工程指示 / 要求簡箋 ENGINEER INSTRUCTIONS(E.I.)

工程指示編號:	EI- 4891	修改版本:	-
	HK- 1177		
工程編號:	J 853	工程名稱:	NKIL6542
收件人:	生統 / 技術部 / 謝永林	發件人:	BearLam
工程項目:	T1-T7各座幕牆單元件SH窗 手柄中與橫料面距離更正 為532.5mm	日期:	18/07/2022

PROJECT : PROPOSED RESIDENTIAL DEVELOPMENT AT N.K.I.L. 6542 YIN PING ROAD KOWLOON

DWG NO. : J853-SD-CW-6003 REV. : A

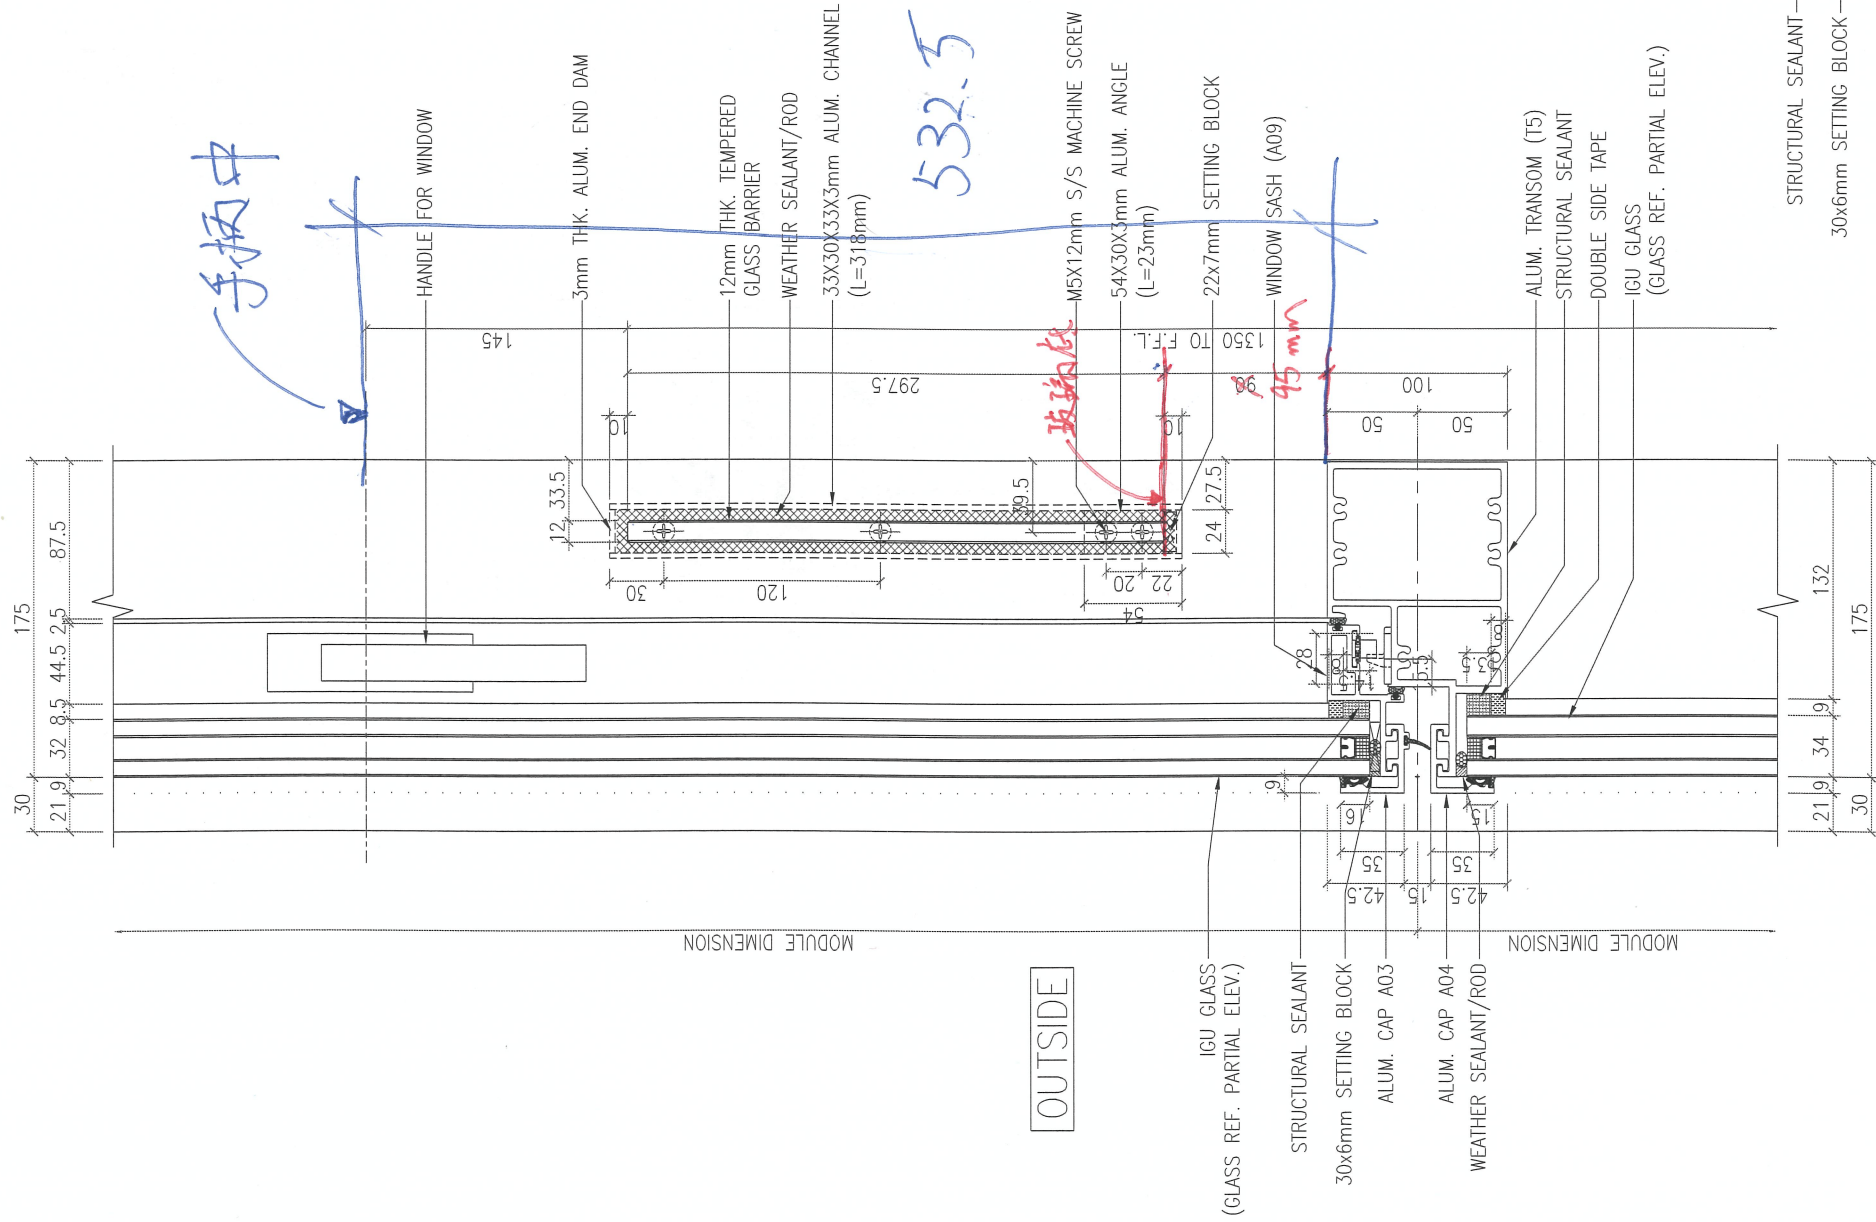
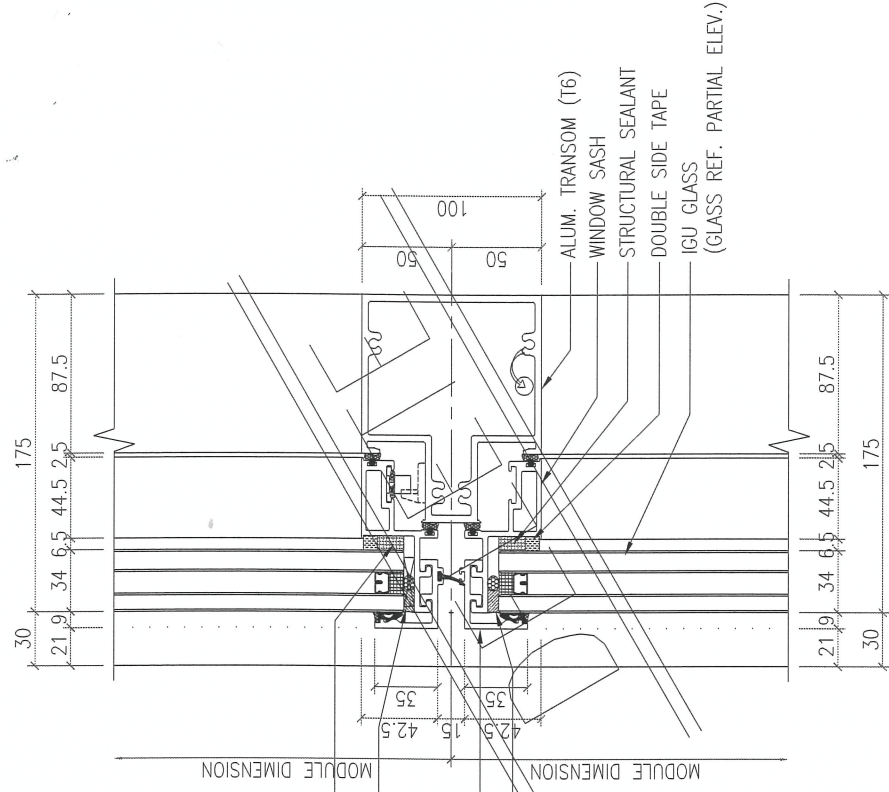
內容: 現附上最新圖紙, 現修改SH窗與橫料的高度, 距離改為532.5mm, 請大貨生產時注意相關高度修改。(見附圖)
